UNITED STATES PATENT AND TRADEMARK OFFICE

10/716,988

SIMPLIFIED "T" INTERCHANGE DESIGN

Figure 7

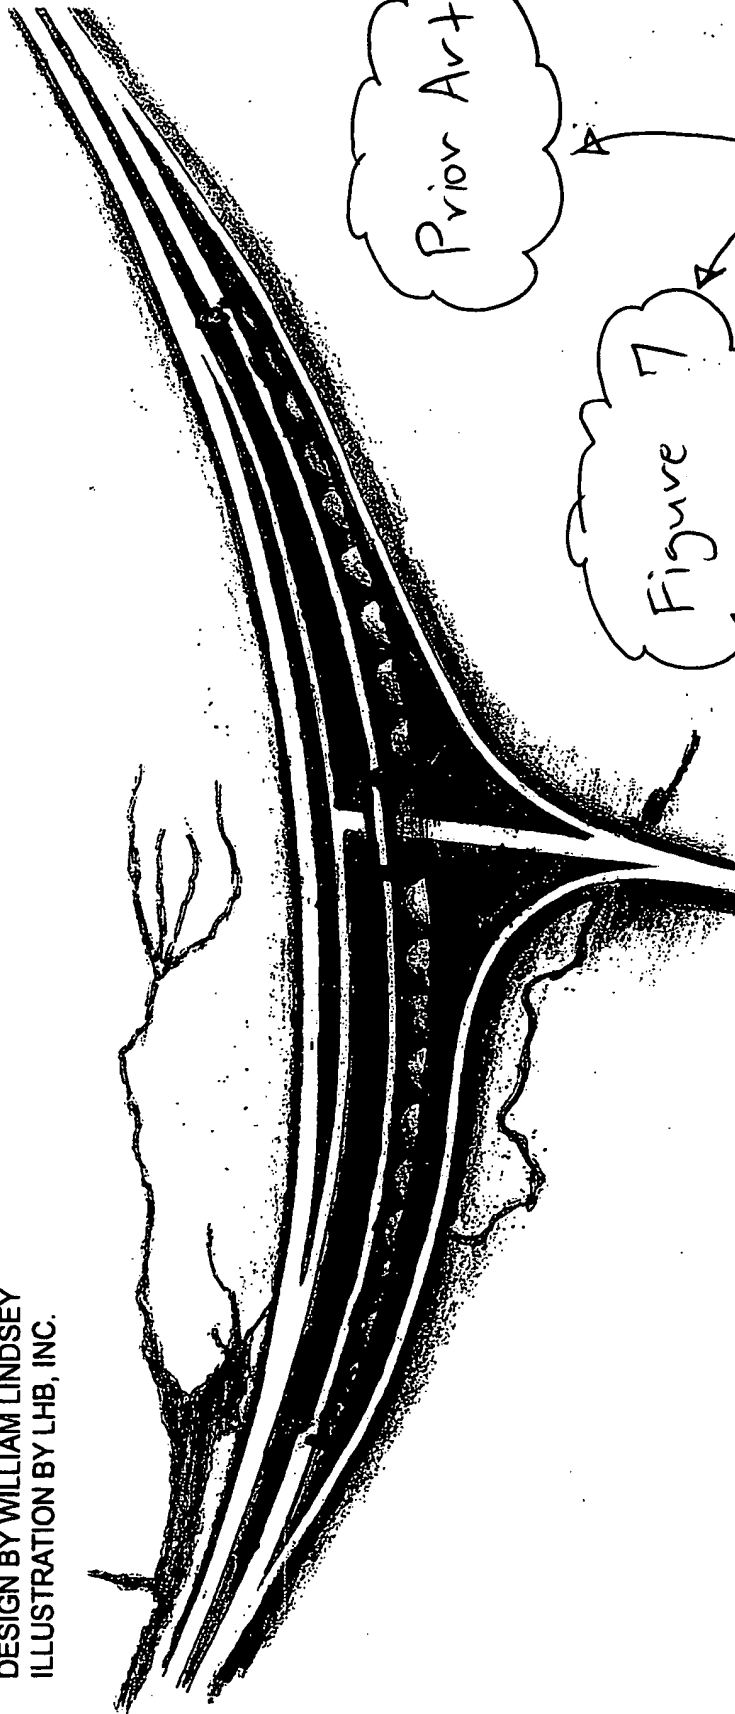
1. Figure 7 (submitted with the applicant's response dated 4/13/06) should be designated by a legend such as --Prior Art-- because only that which is old is illustrated. Additionally, the figure must be labeled --Figure 7--. The re-submitted drawing must be labeled --Prior Art-- and --Figure 7-- in order to be approved. See MPEP § 608.02(g). Corrected drawings in compliance with 37 CFR 1.121(d) are required in reply to the Office action to avoid abandonment of the application. The replacement sheet(s) should be labeled "Replacement Sheet" in the page header (as per 37 CFR 1.84(c)) so as not to obstruct any portion of the drawing figures. If the changes are not accepted by the examiner, the applicant will be notified and informed of any required corrective action in the next Office action. The objection to the drawings will not be held in abeyance.

THESE
LABELS ARE
REQUIRED IN
THE RESUBMITTAL

NOT APPROVED
